CITY OF WEST LAKE HILLS, TEXAS
NOTICE OF CITY COUNCIL REGULAR MEETING
Wednesday, July 28, 2021 at 7:00 PM

- 6. **Land Use 1405 Wildcat Hollow:** Discuss and Consider Action on Supplemental Variance Requests for the Following:
 - 1. Variance for cut and fill for temporary existing 10 foot steel retaining wall and resulting final 5 foot retaining wall after tiered construction completion; and

- 7. **Ordinance** Discuss and Consider Action to Adopt an Ordinance Amending Chapter 22, Article 22.03, Sections 22.03.175(e)(1) and 22.03.249(b)(4), of the Code of Ordinances, to modify the height requirements for driveways in residential and non-residential areas

NOTES
L-002

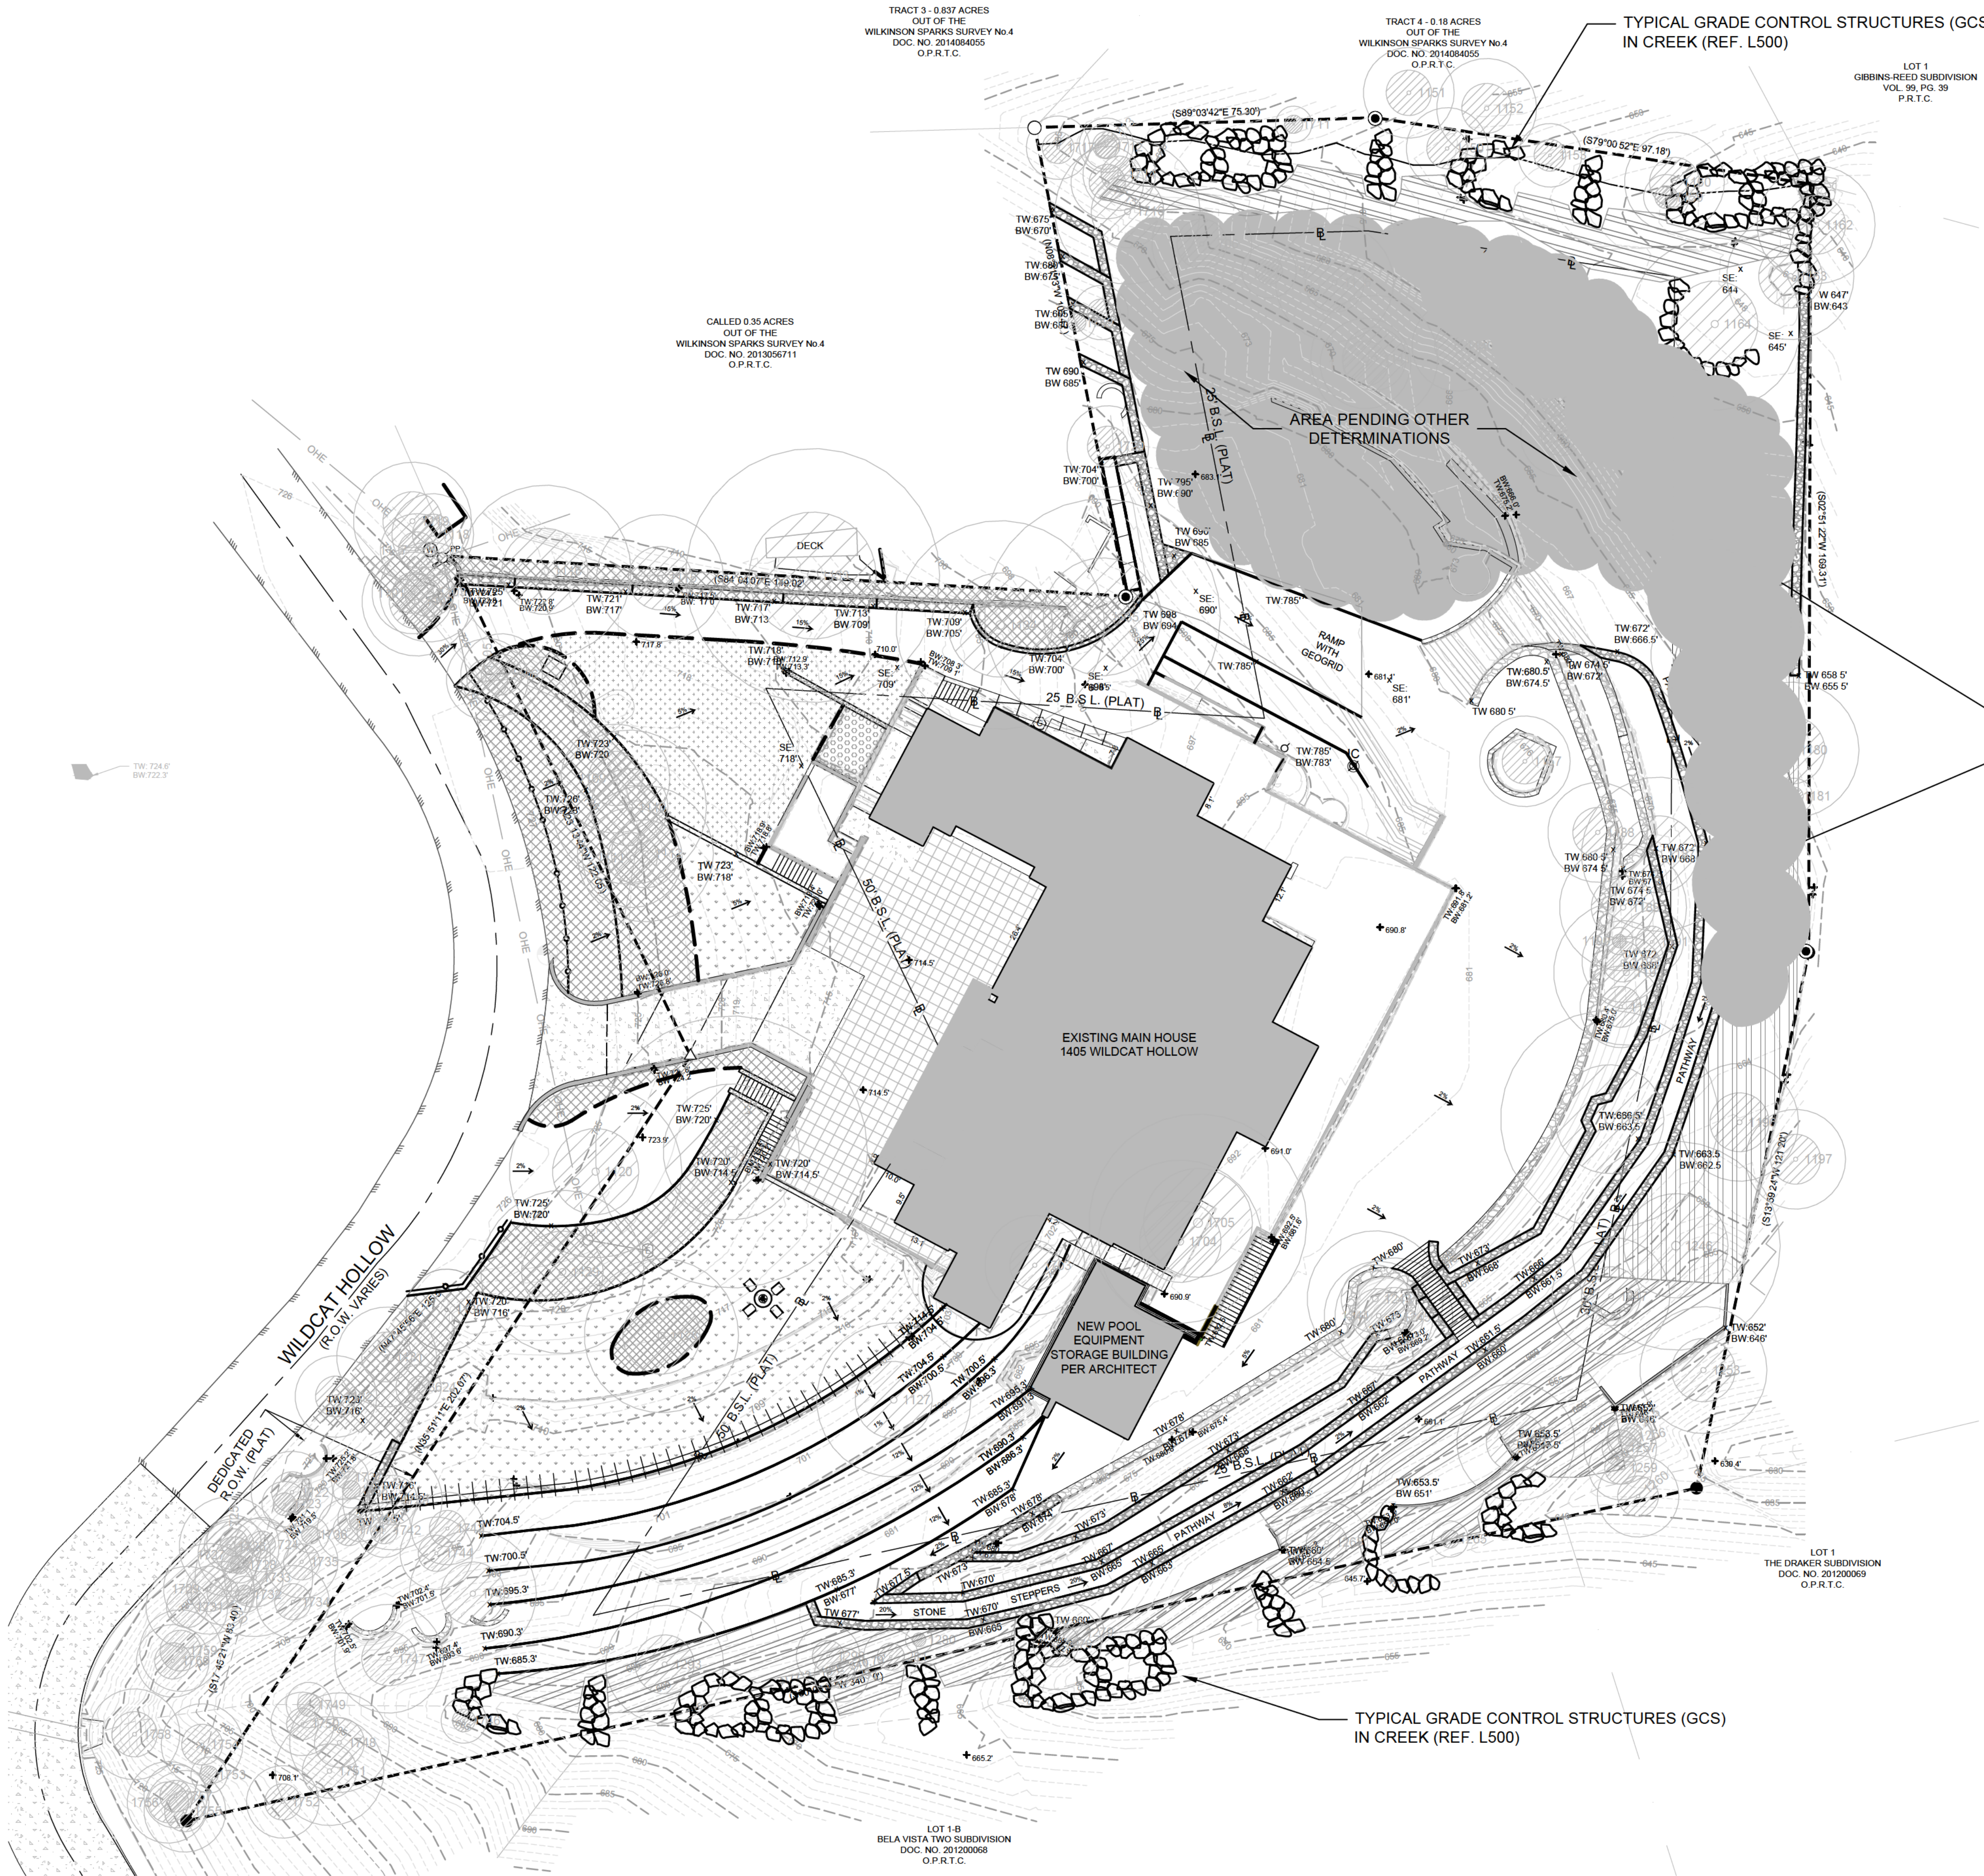
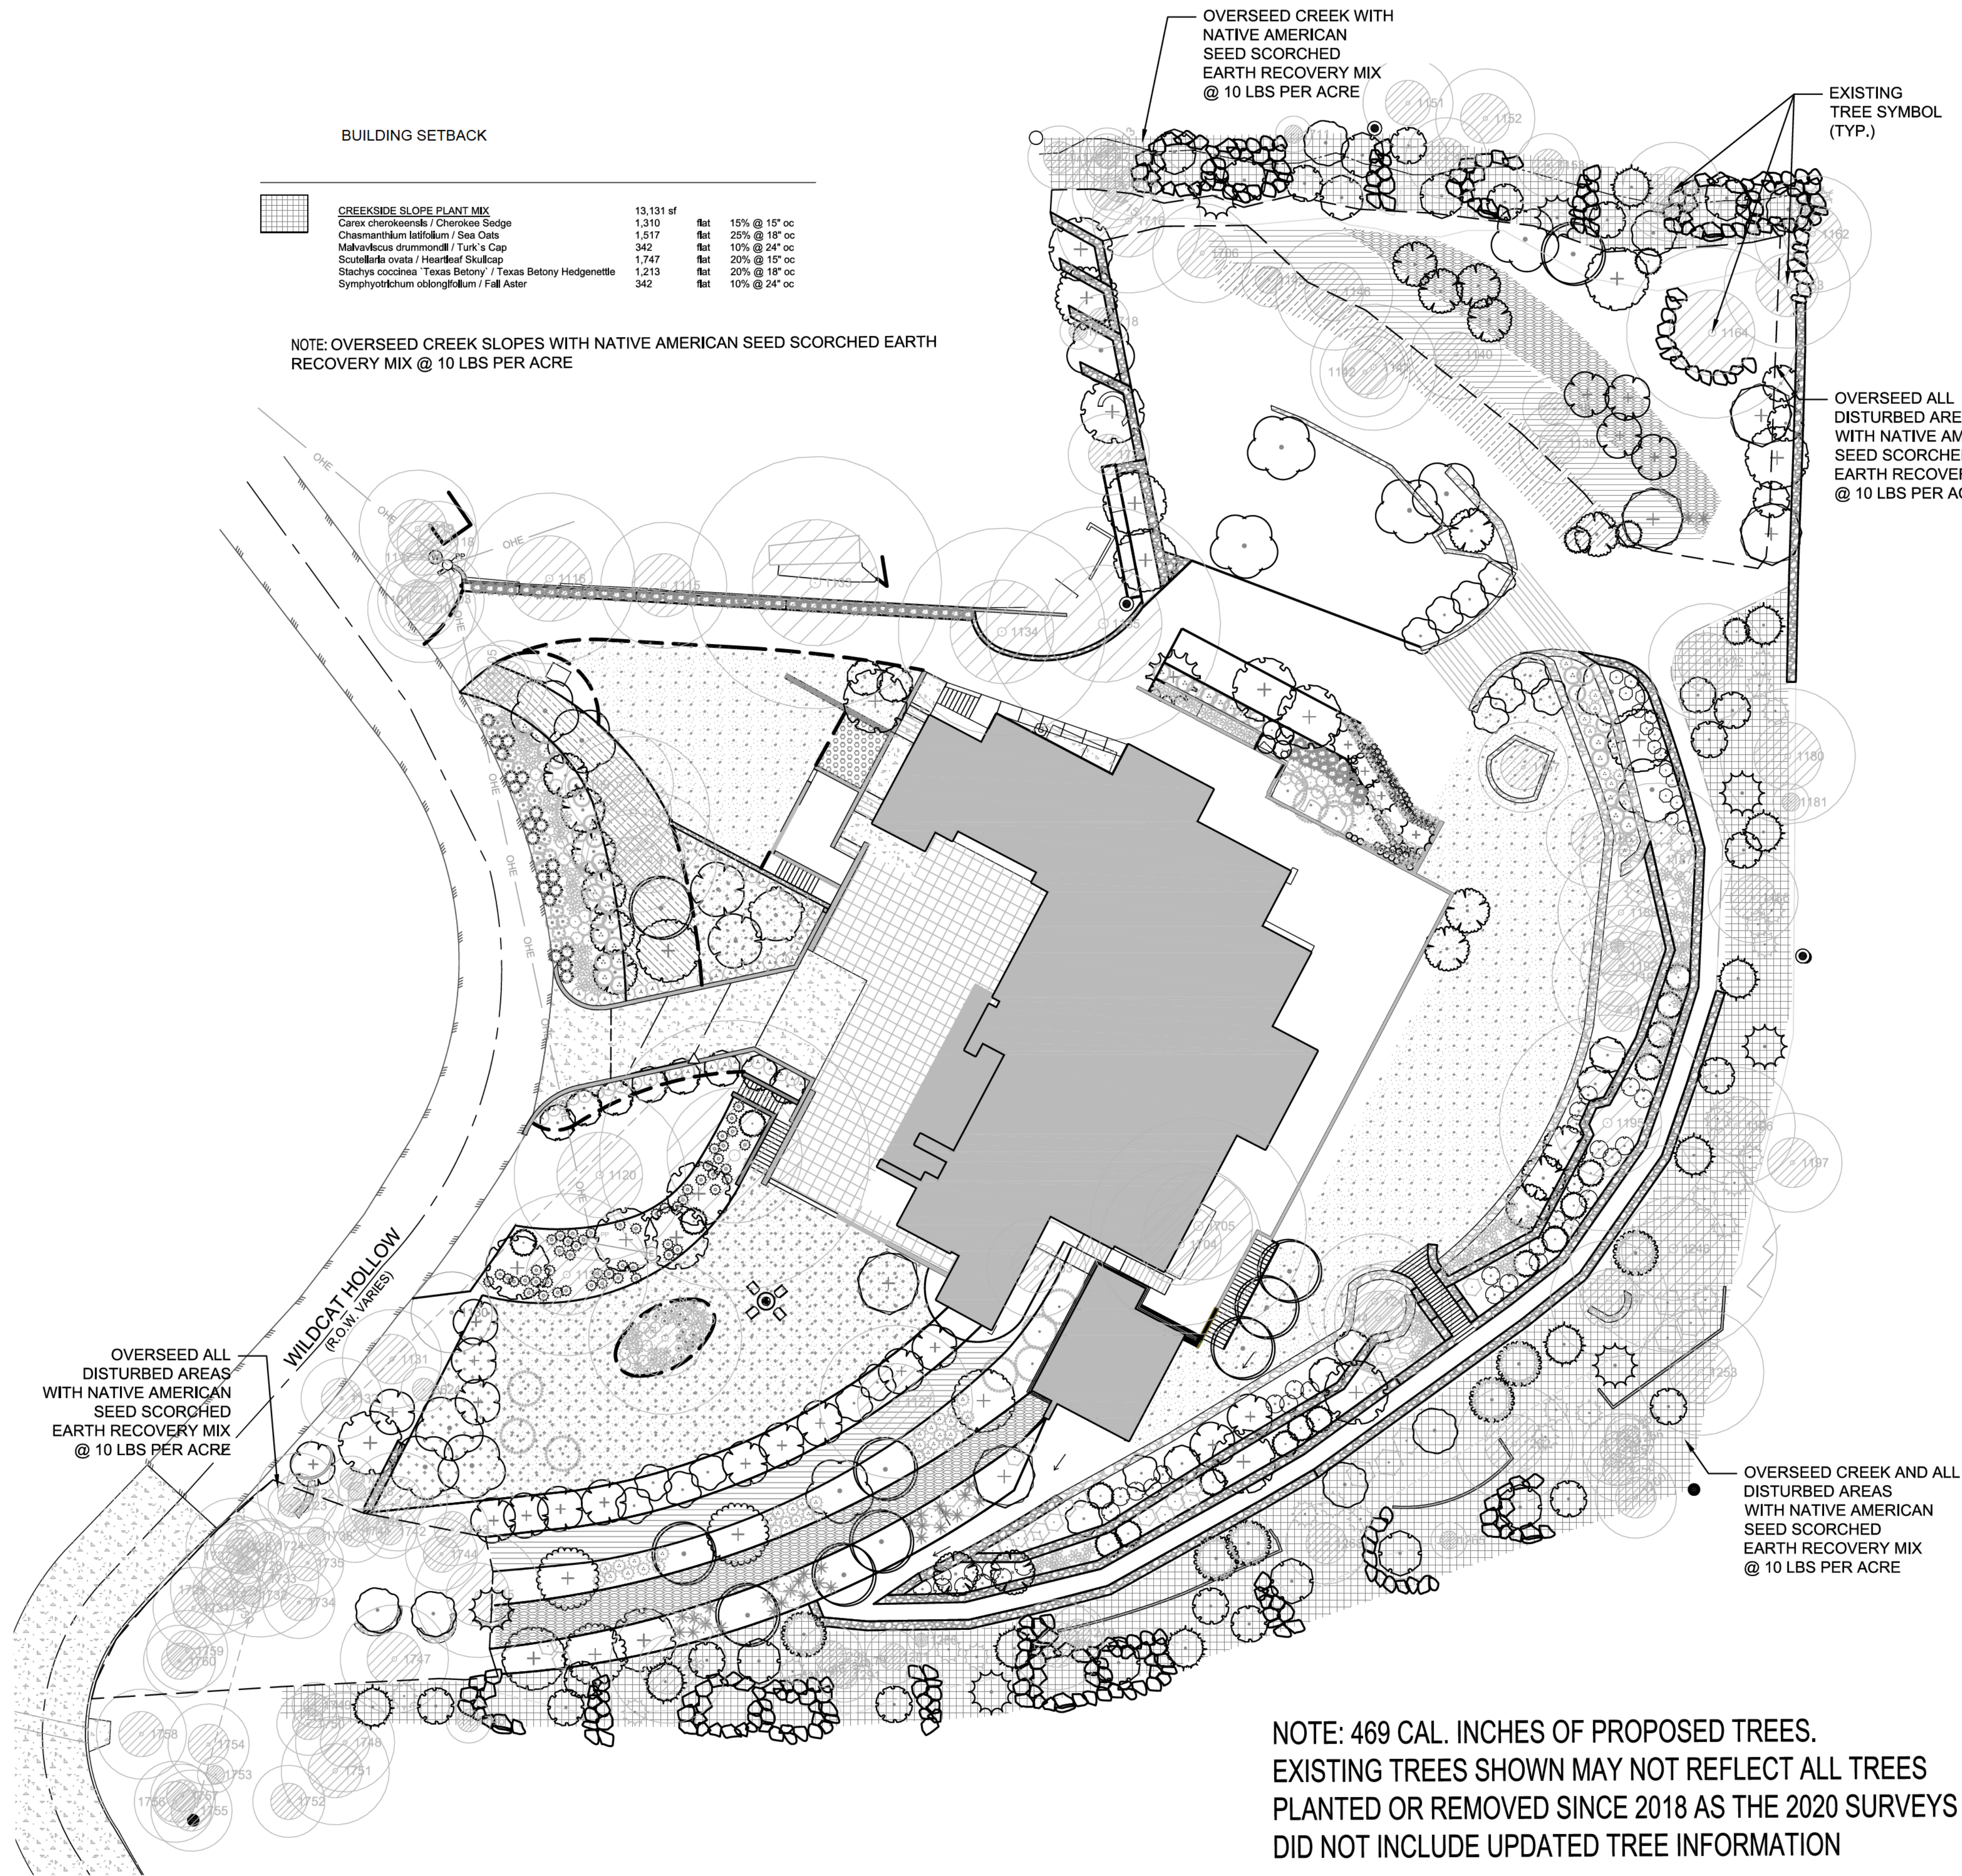
A General Plan Note on Sheet L-001 indicates that the scope of work will “stabilize disturbed slope and lower the height of steel walls already in place that exceed 6 feet tall.” In addition, a note on Plan Sheet L-500 indicates that “all steel (and stacked rock) walls over 4 feet tall require structural engineering.” While it does not appear that all of the existing walls are over 6 feet tall, they all appear to be at least 4 feet in height.

A General Plan Note on Sheet L-001 indicates that the scope of work will “stabilize disturbed slope and lower the height of steel walls already in place that exceed 6 feet tall.” In addition, a note on Plan Sheet L-500 indicates that “all steel (and stacked rock) walls over 4 feet tall require structural engineering.” While it does not appear that all of the existing walls are over 6 feet tall, they all appear to be at least 4 feet in height.

LANDSCAPE
DETAILS
L-500

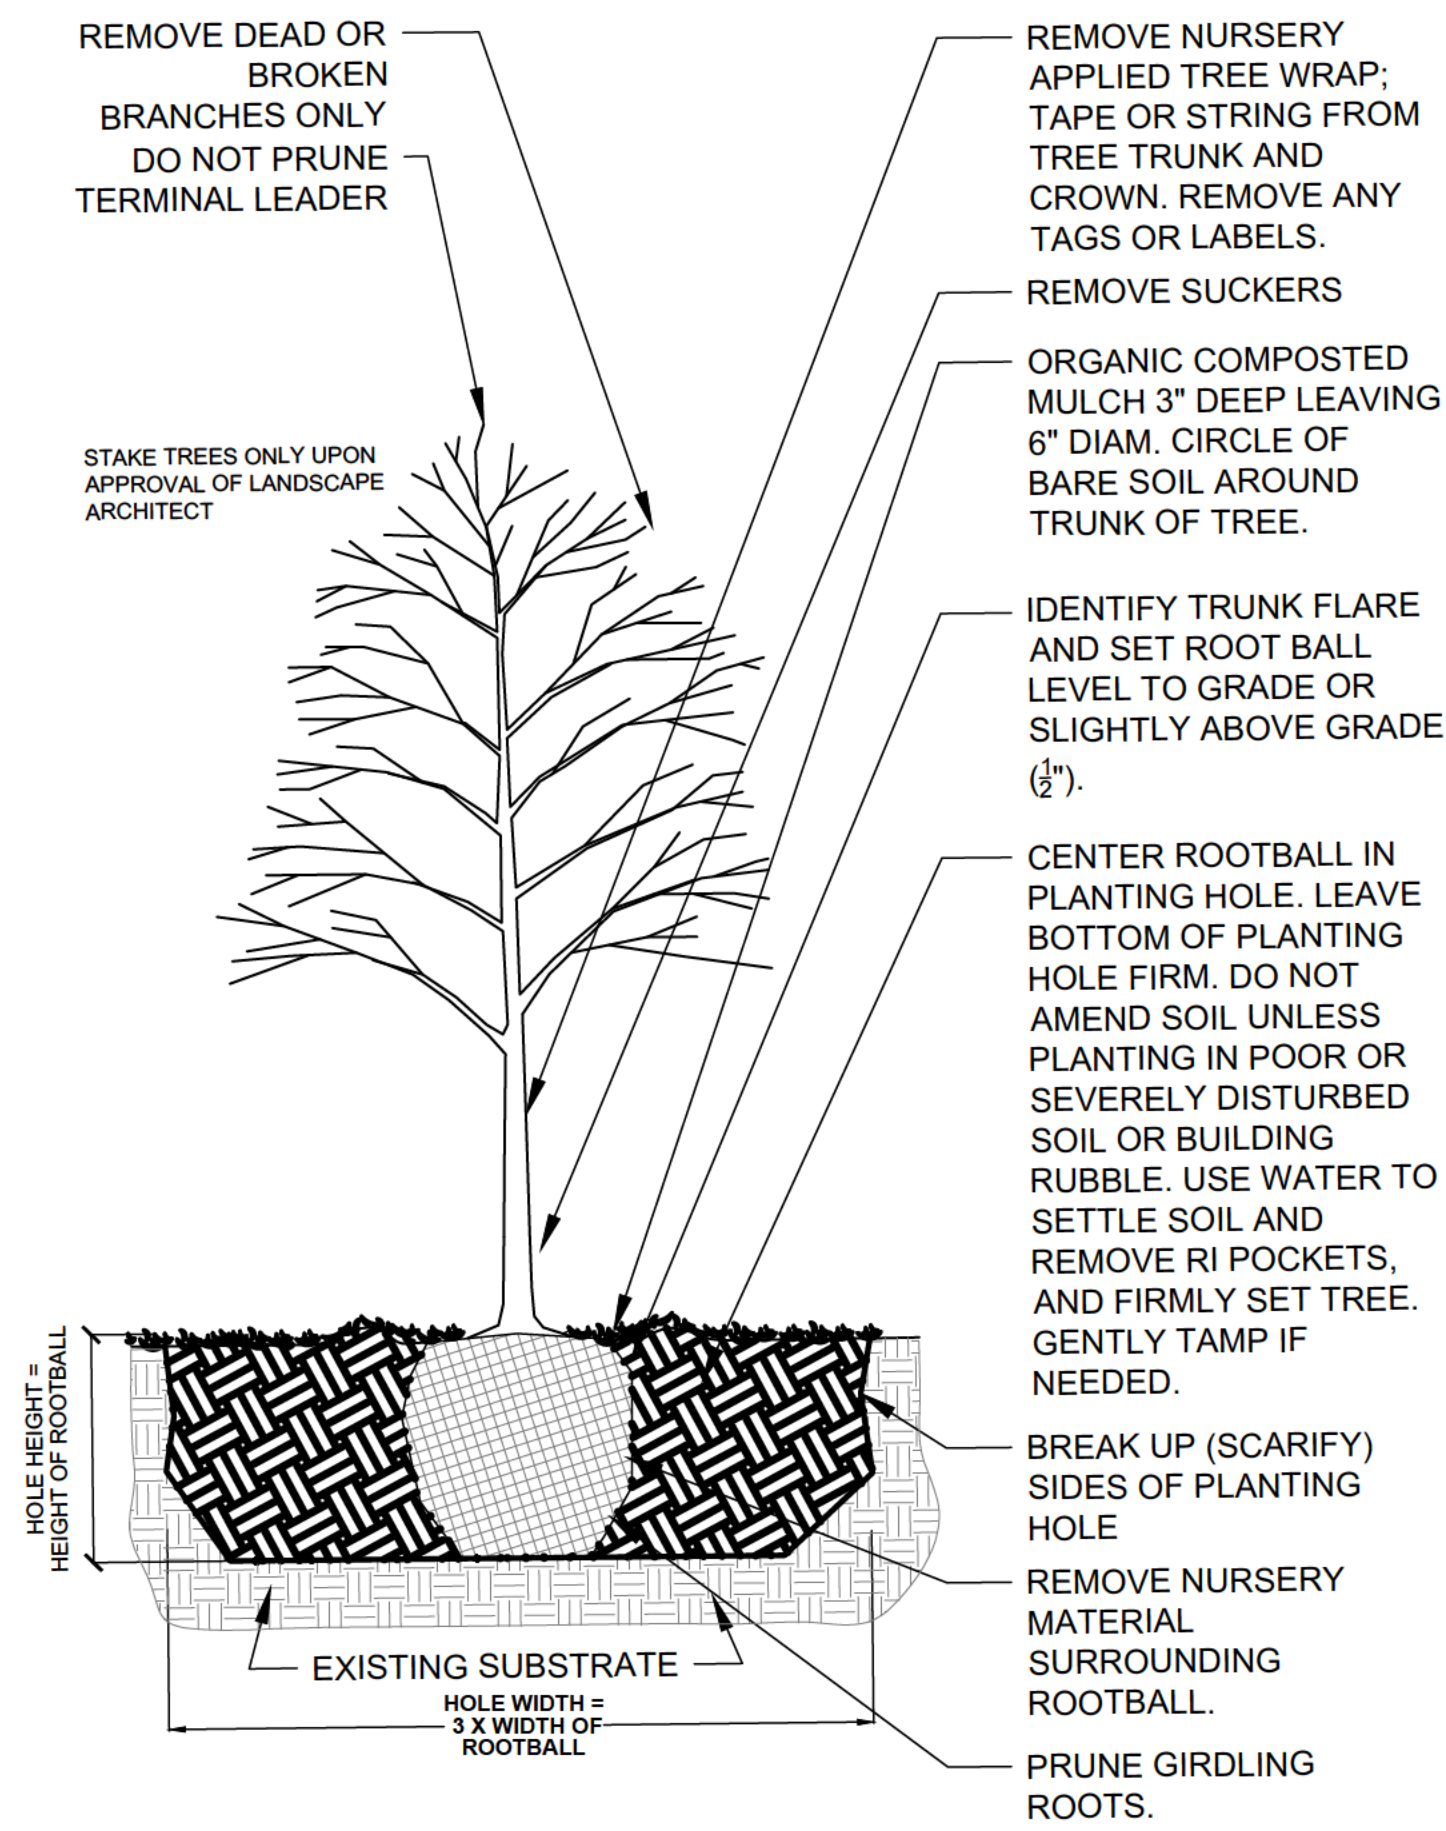
A site visit indicates that there is some grade separation at the bottom of each of the existing walls. While it appears that rubble rock has been stacked along some areas of the grade separations, is additional grading and/or reinforcement proposed and/or required to preserve or restore their structural integrity? Please address this question in your variance application. (It should also be noted that the plan profile of steel retaining walls on Sheet L-500 shows the bottom of the steel sheet terminating beneath finished grade.)

A site visit indicates that there is some grade separation at the bottom of each of the existing walls. While it appears that rubble rock has been stacked along some areas of the grade separations, is additional grading and/or reinforcement proposed and/or required to preserve or restore their structural integrity? Please address this question in your variance application. (It should also be noted that the plan profile of steel retaining walls on Sheet L-500 shows the bottom of the steel sheet terminating beneath finished grade.)
